Our Ref: 2394/01

## **RE: RETAIL, OFFICE & RESIDENTIAL DEVELOPMENT AT 152-156 KENTISK TOWN ROAD**

As requested, we outline below an explanation of the basement works relating to Condition 19 of the planning approval in connection with the lightwell treatment at the above site.

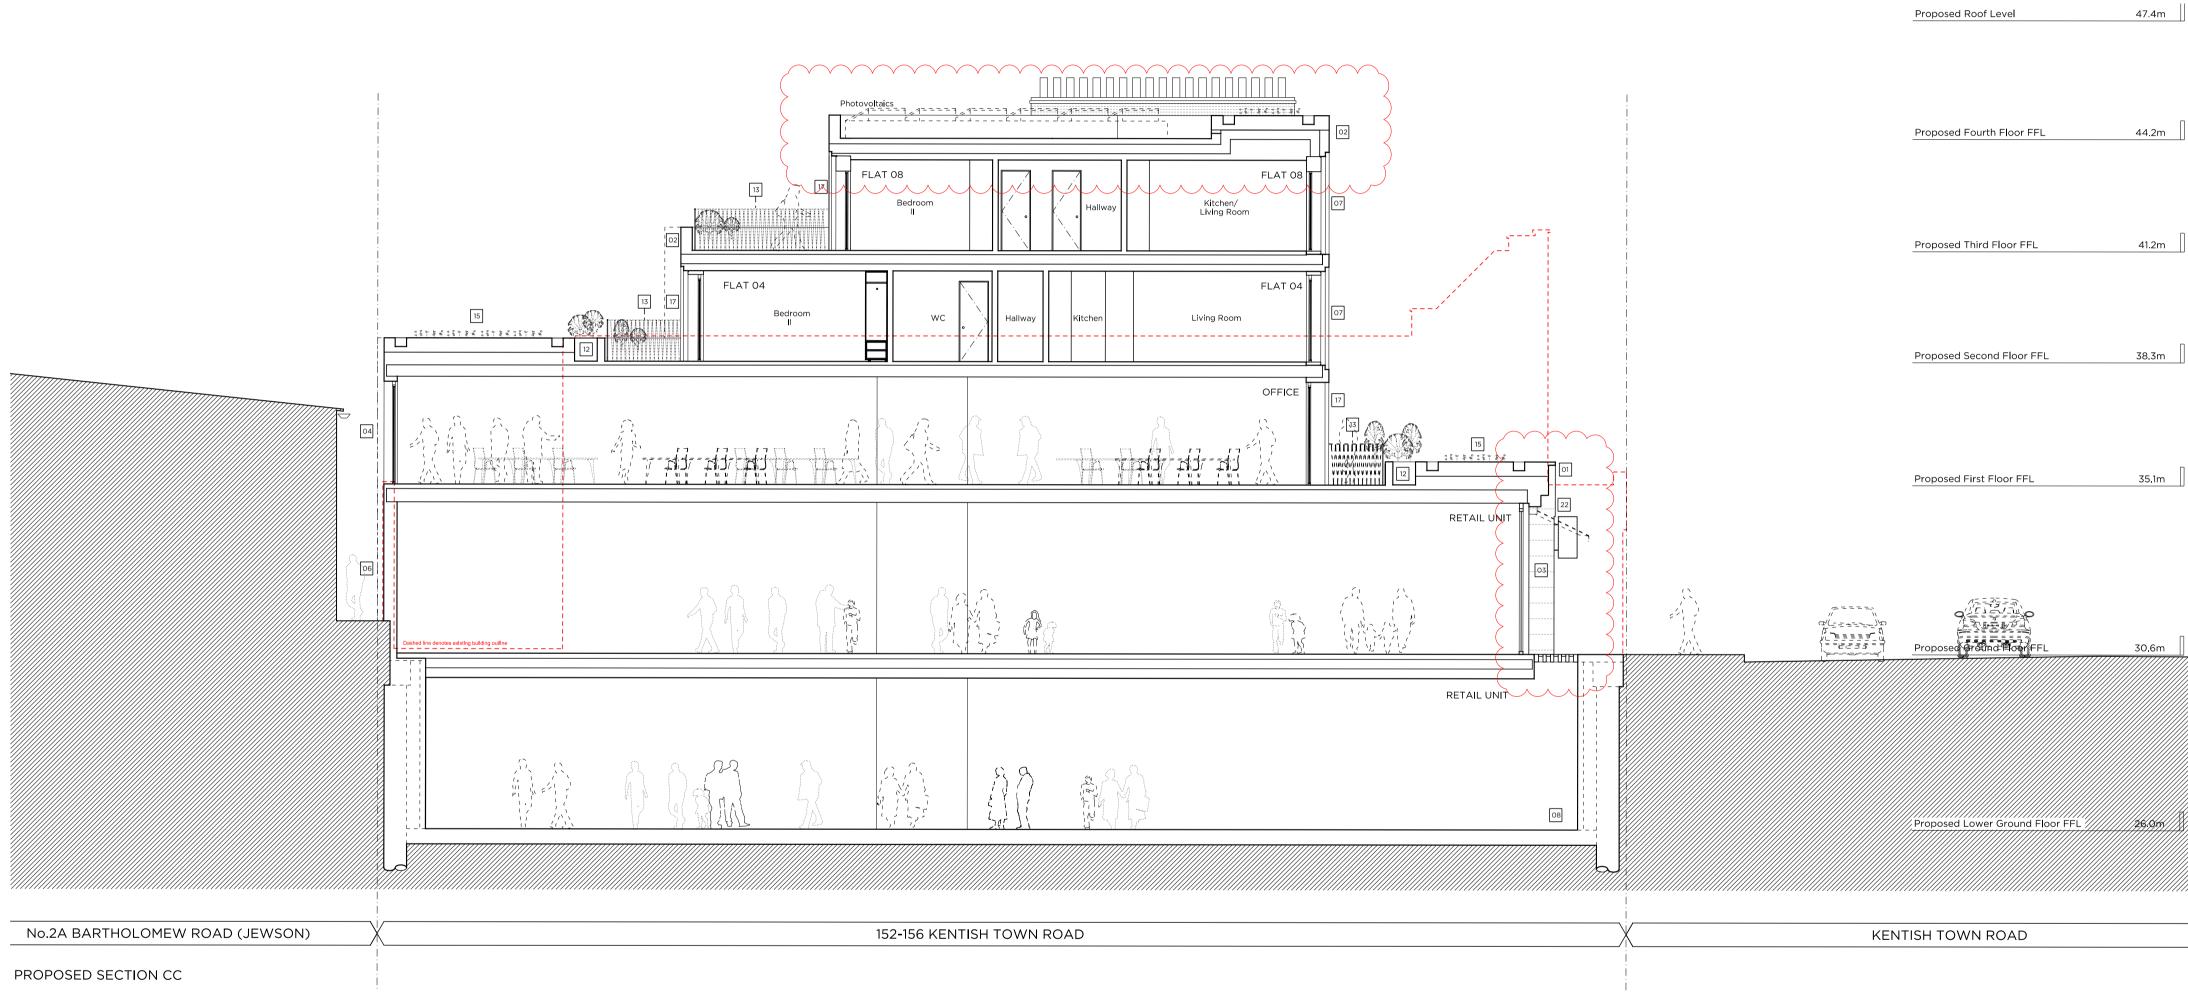
The Architectural original concept included for lightwells along the footpath to Kentish Town Road as shown on the attached drawings number P14-C. This served a much larger new basement area.

Since the construction of the new basement requires secant piled retaining walls to four sides of the site footprint, the line of piles along London Under Ground (LUG) tunnels in Kentish Town Road were considered and in previous consultation with LUG this proposal was found to be unacceptable due to the location of the piles being within the allowable minimum limit of 3.0m to the side of any existing tunnels.

Due to LUG's objection to the original proposal, the width of the basement was reduced thereby removing the proposed lightwells and locating the piles away from LUG's 3.0m limit to their asset. BJB Consulting's drawing number 2304-BJB-00-ZZ-DR-S-0206-P04 confirms the final previously agreed arrangement of the piles in relation to the existing tunnels therefore the planning condition relating to the lightwells is no longer relevant.
